PUBLIC INTEREST REVIEW FOR GROUNDWATER APPLICATIONS

Application G-17863

Date: 7/03/2014

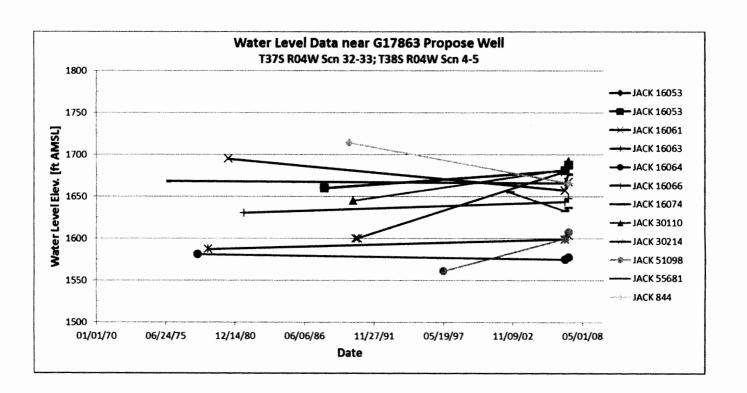
re	here are few existing groundwater rights in the area (listed below) but the greatest possible substantial impact will be to sidential wells located southeast of the proposed well (see map). At the proposed rate, hydraulic interference should be inimal.							
<u>ri</u> m av	ert. 15239 and 15238 are SW rights for diversion from nearby abandoned mine tunnels. Although these are surface water ghts they are likely acting as GW wells (withdrawing GW as is seeps into mine tunnels) depending on the depth of the ines they could access the same bedrock groundwater resource as the proposed use. There is no construction information railable to determine that injury from the proposed use is likely. Let GR 2241 is a shallow (55') well accessing the alluvial aquifer and will not likely be impacted by the proposed well if the
